ADDENDUM NO. 2

Population Management NLEF Fence- Phase 4
DRC-21F020

Date: November 27, 2023

Location: Ross Correctional Institution
16149 St Rt 104
Chillicothe, Ohio 45601

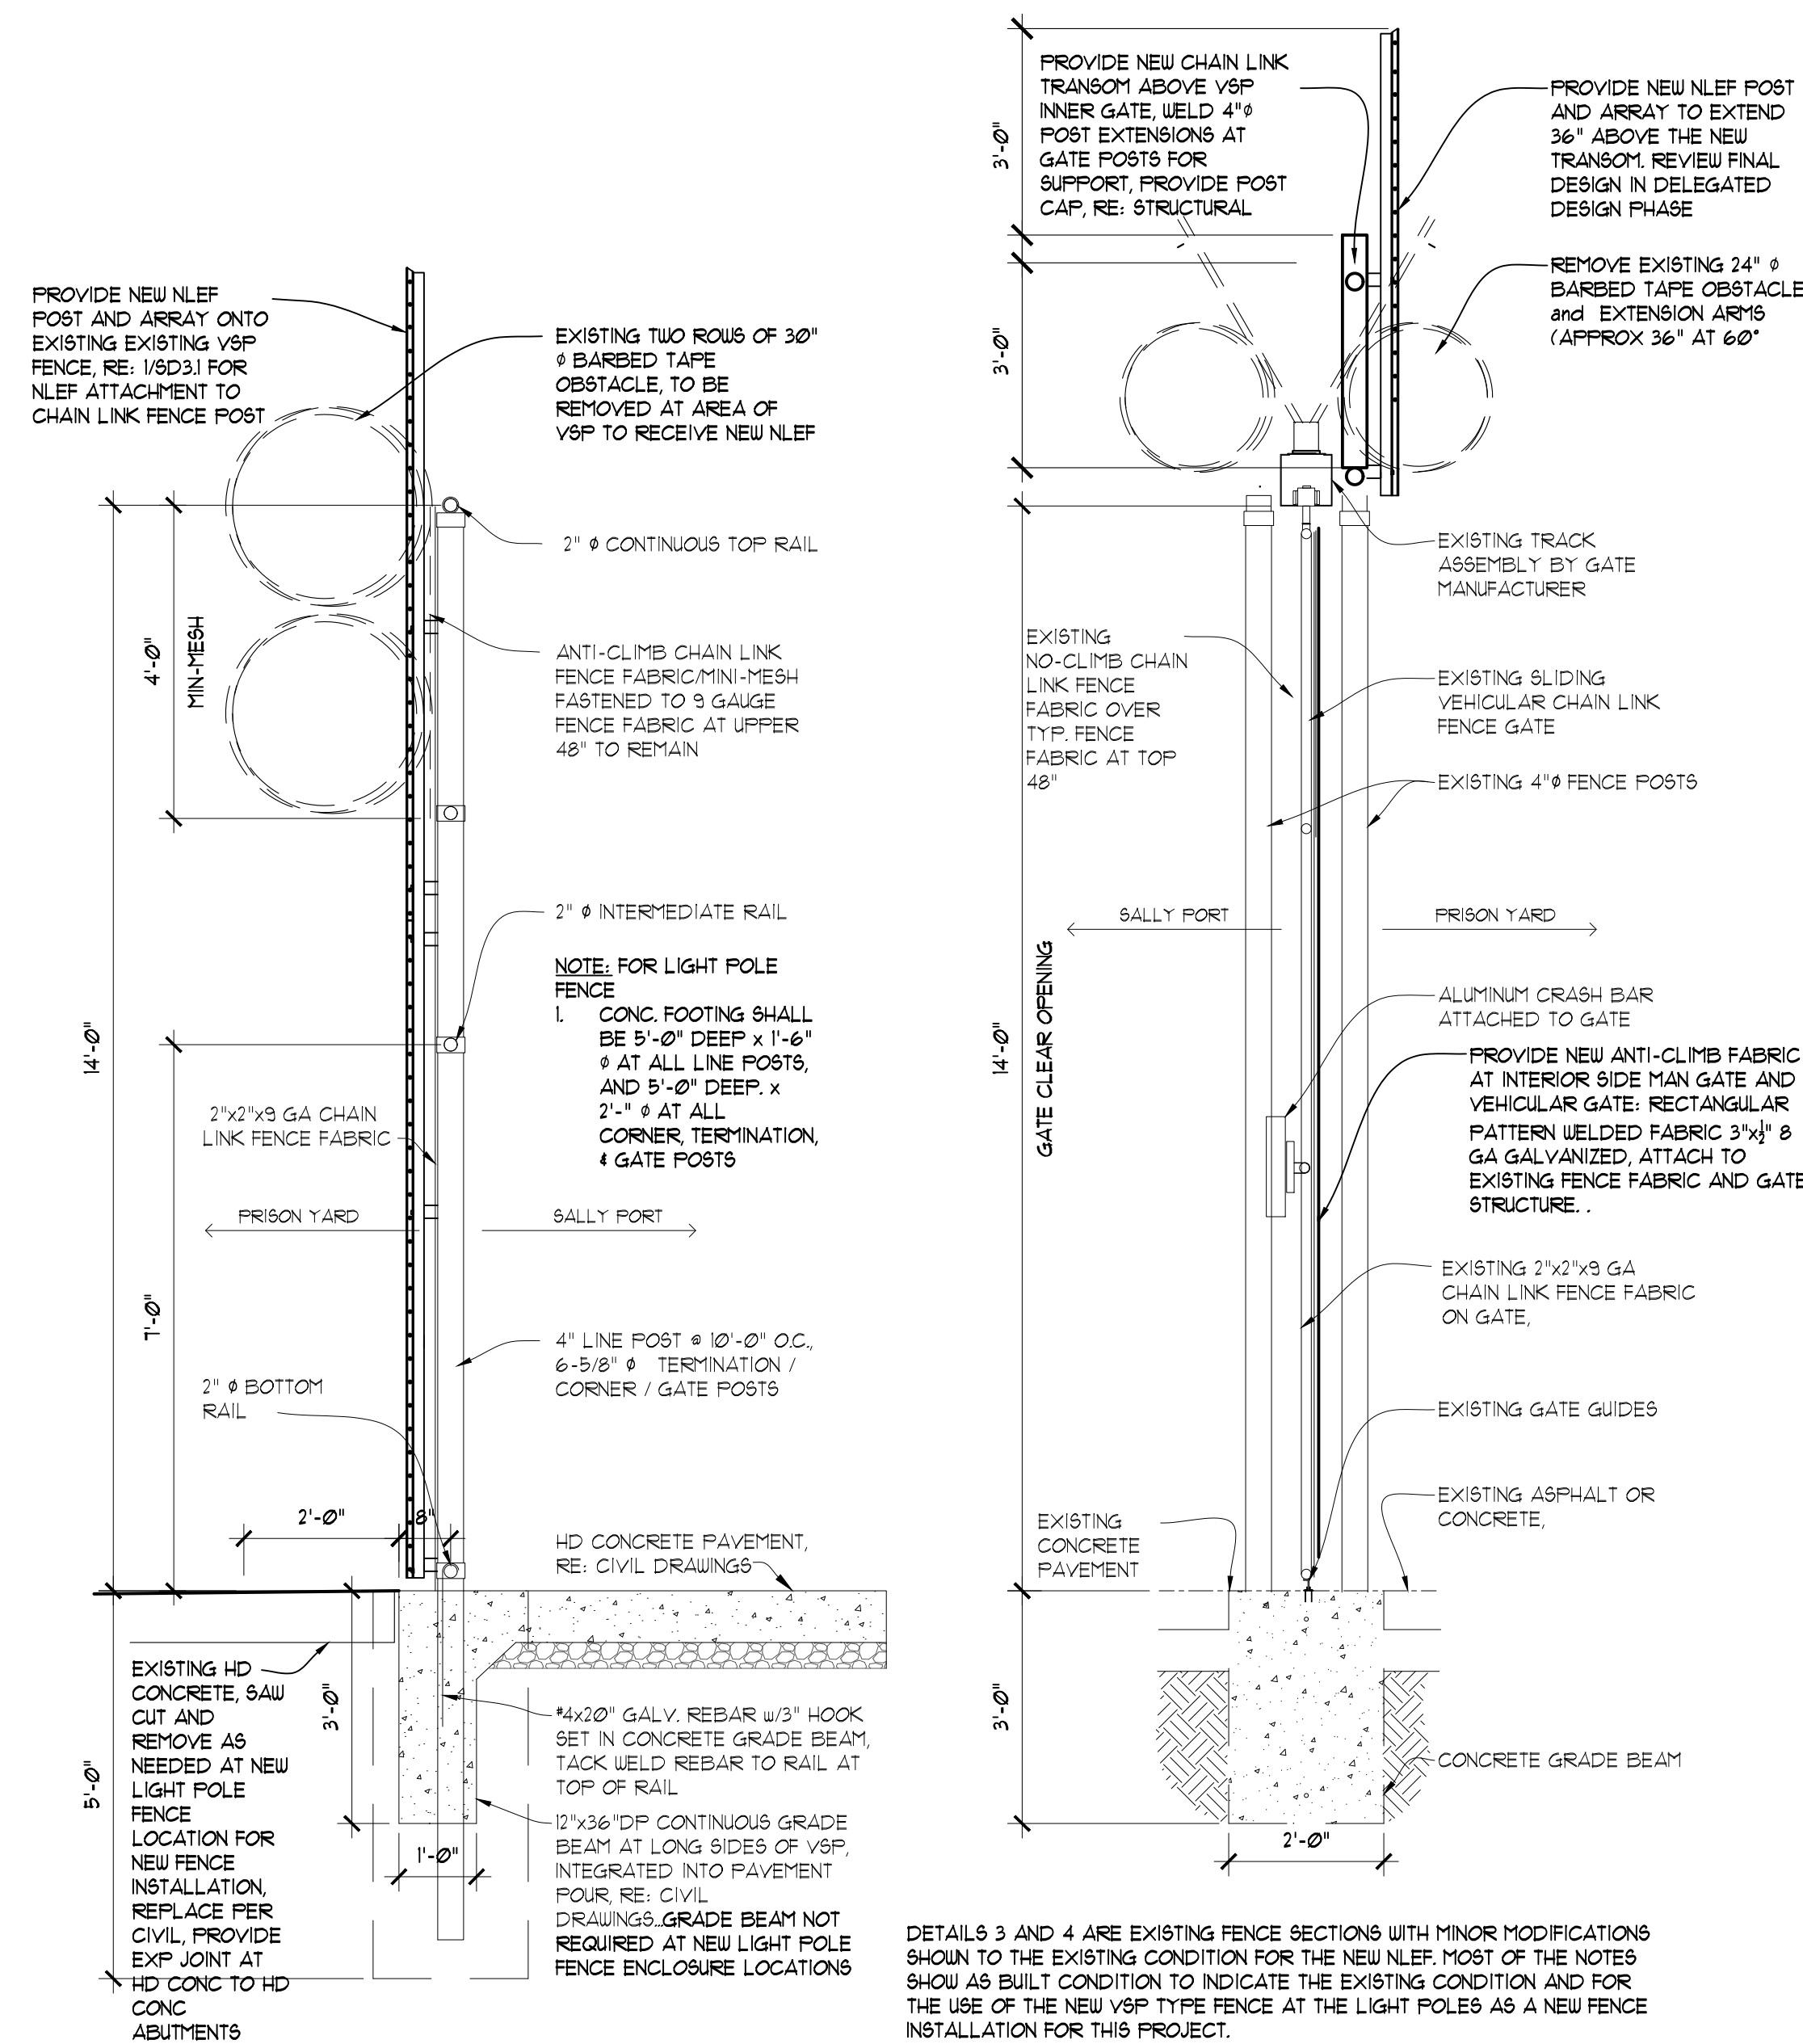
- ITEM 20:** Drawing SD3.1:
1. Detail 1/SD3.1 revision showing 1-5/8" rails (addendum 1), and revised fence fabric height of 7' per Item 8 spec revisions above.
 2. Detail 4/SD3.1, now shows locations of the traffic bollards detailed in 6/S5.0. Four (4) needed per field cabinet enclosure.

1 DETAIL - DUCT BANK DIRECT BURIED CONDUITS

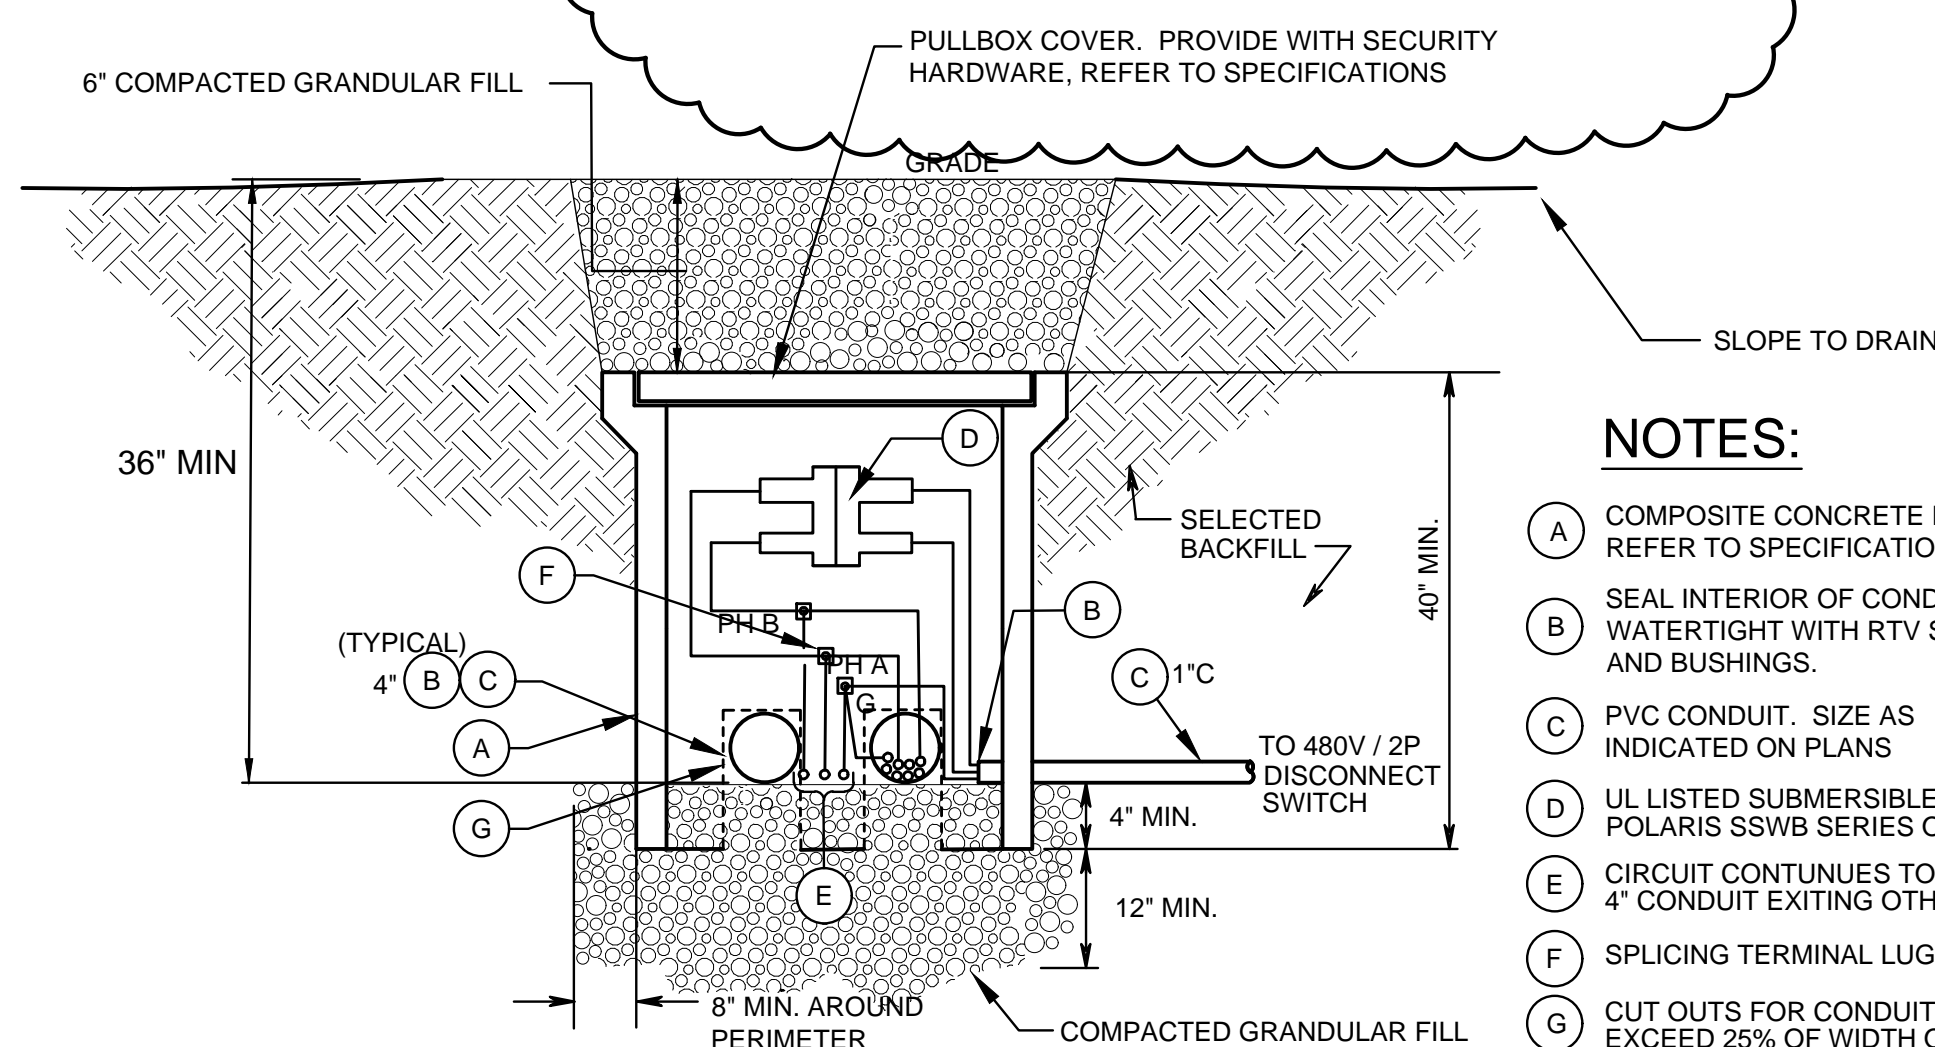
- ITEM 22:** Sheet E5.1: Detail 1/E5.1, added notes to provide option for a single trench providing the same separation of the card reader conduit.

NOTE: THE 1" CONDUIT FOR THE NLEF CARD READER MAY OCCUPY THE SAME TRENCH AS THE POWER AND FIBER OPTIC CABLES AS LONG AS A MINIMUM OF 12" SEPARATION FROM POWER CONDUITS IS MAINTAINED AT ALL TIMES. IT IS THE CONTRACTOR'S OPTION TO PROVIDE TWO TRENCHES OR ONE.

SHEET
ES2.1

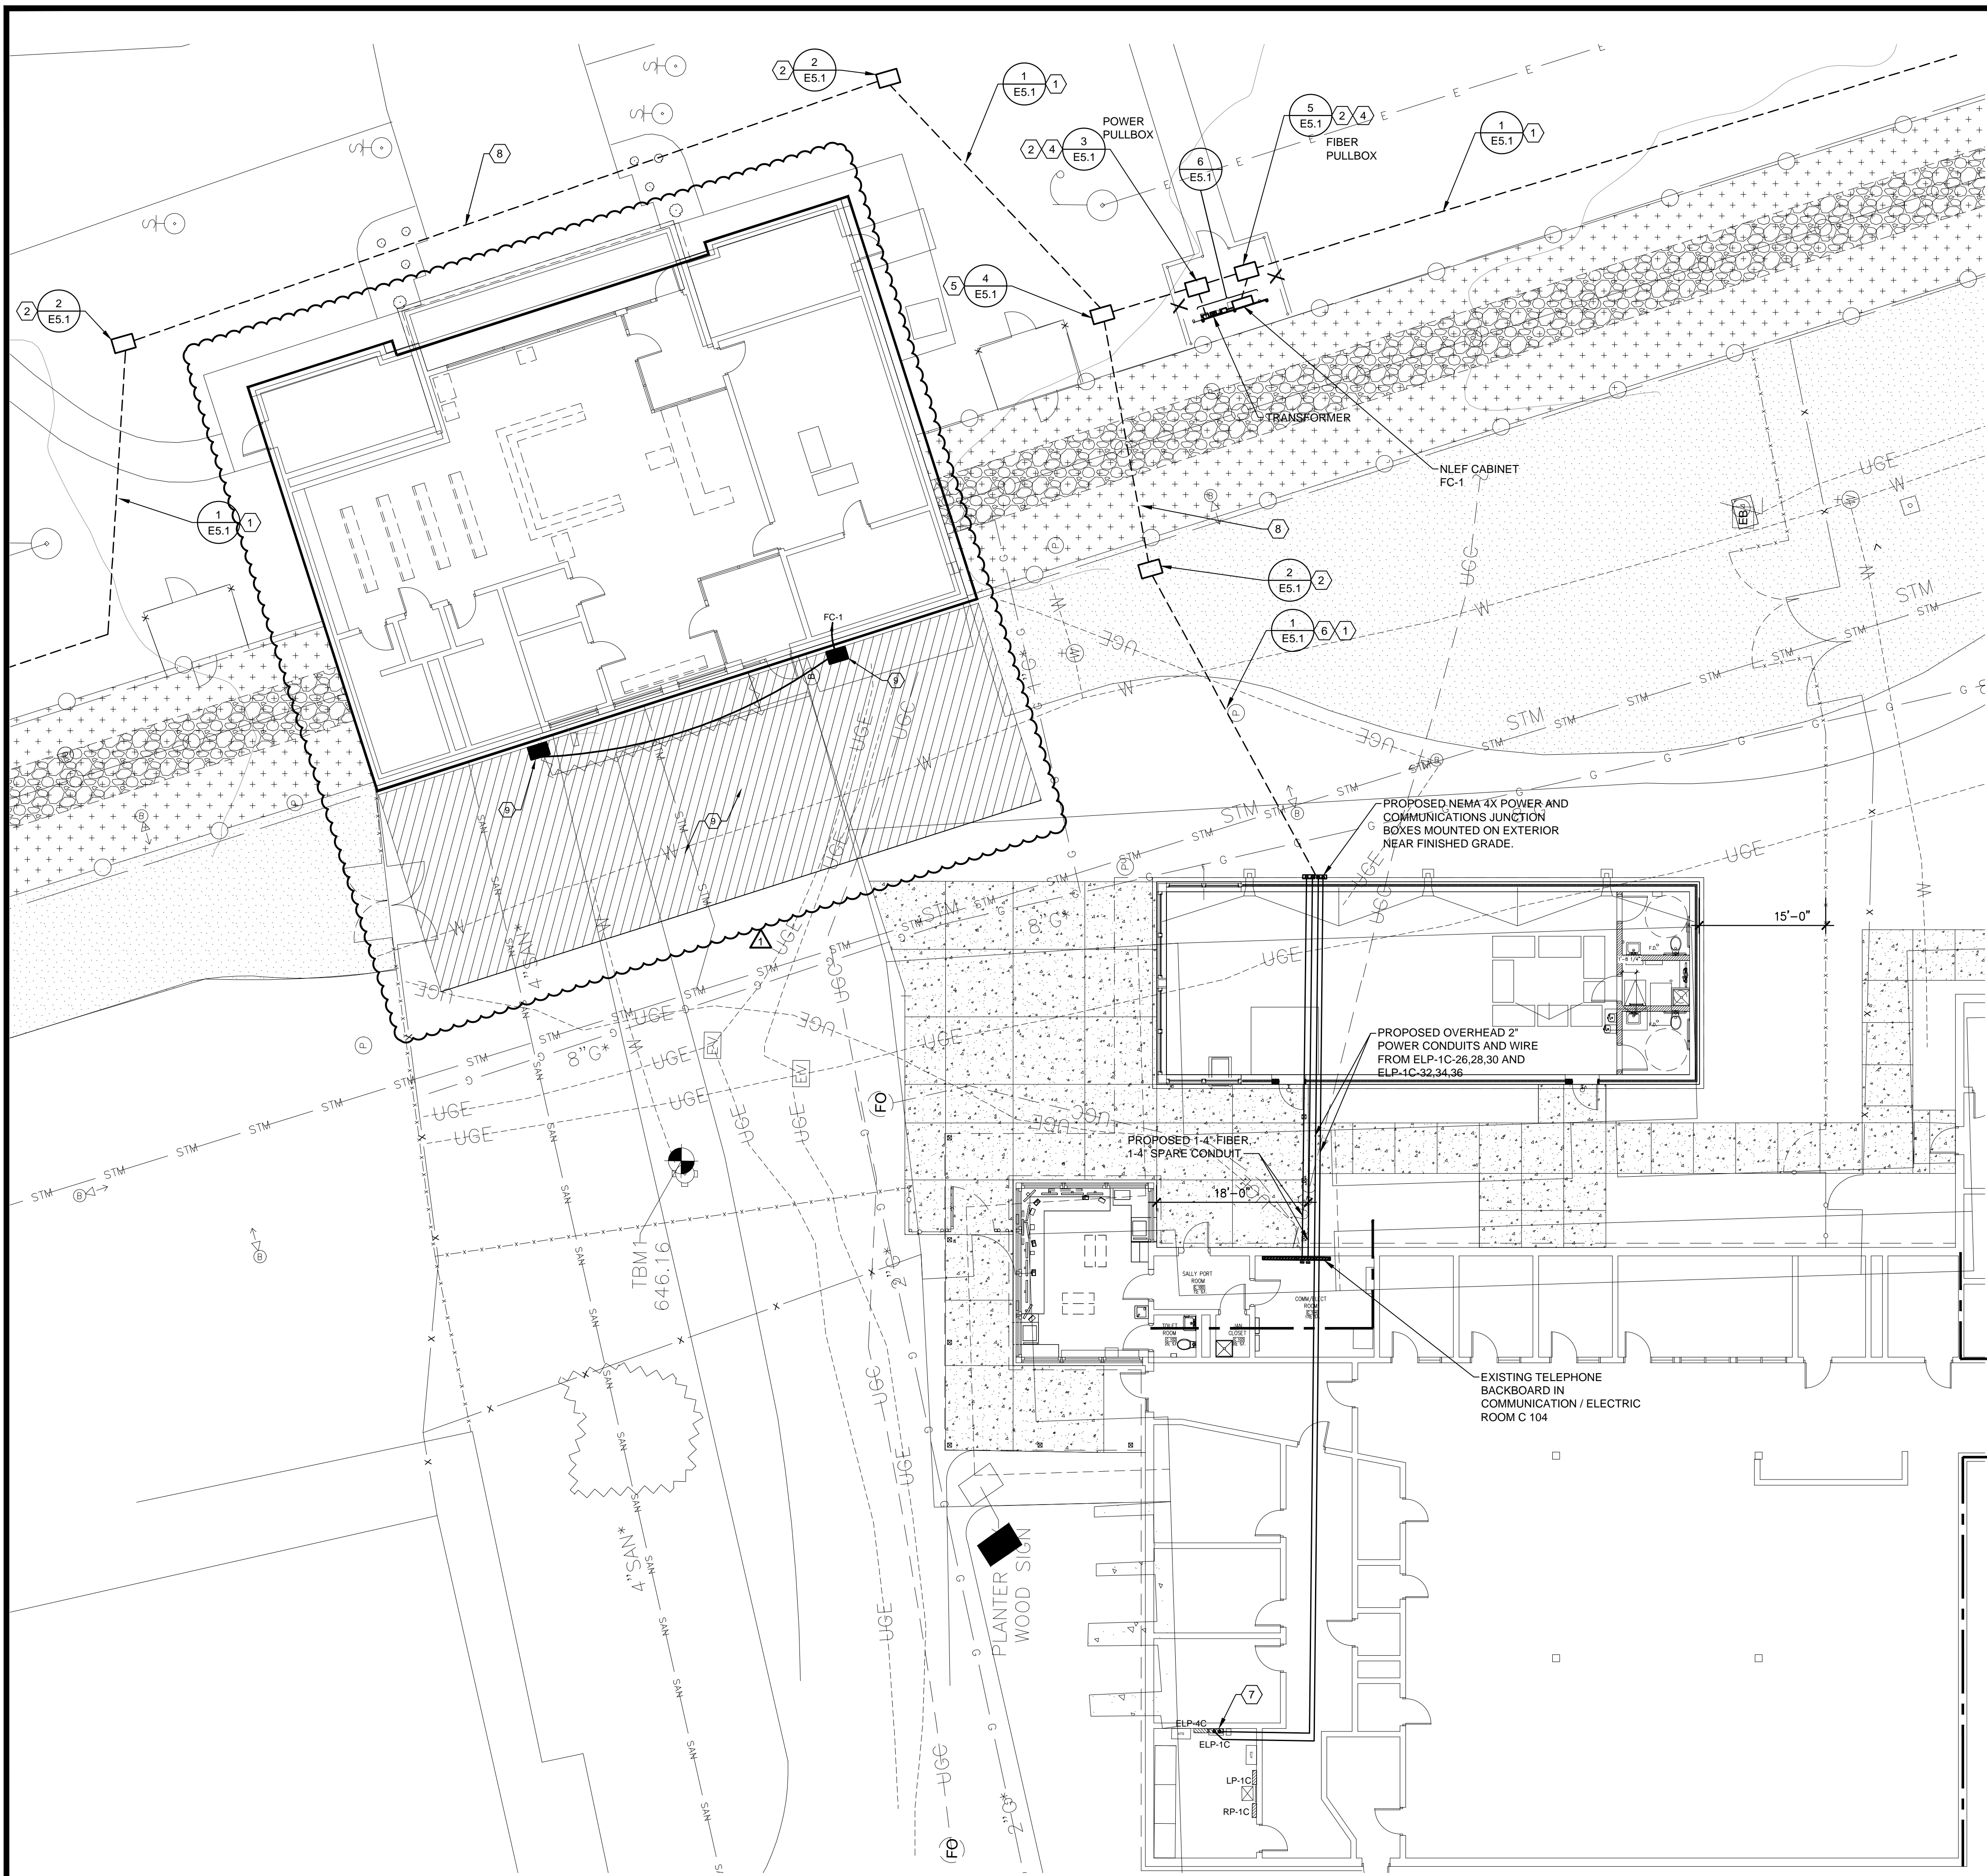
- ITEM 22:** Sheet ES2.1: The two (2) proposed dopplers at the Entry building have been moved from the roof to the inside face of the Entry building, see attached sheet ES2.1.
- Sheet ES2.2: Proposed and existing dopplers at the VSP have some notes added and notes revised, see attached sheet ES2.2.
